**Advisory Action
Before the Filing of an Appeal Brief**

10/666,082

ITO ET AL.

FIG. 1

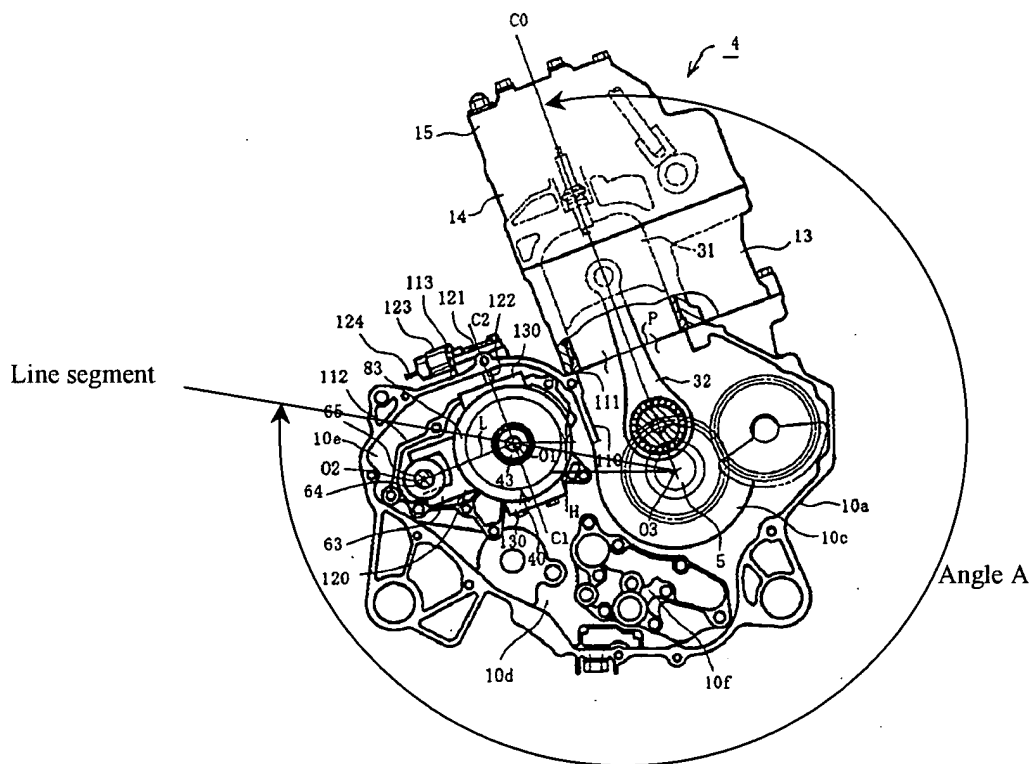
Regarding Applicant's arguments on page 5, paragraphs 4 and 5, note that, in Ito et al., the axis 02 of the shaft 64 is inside of the angle A (see below) defined by a line segment passing through the axis 01 and the axis 03, and the axial line CO.
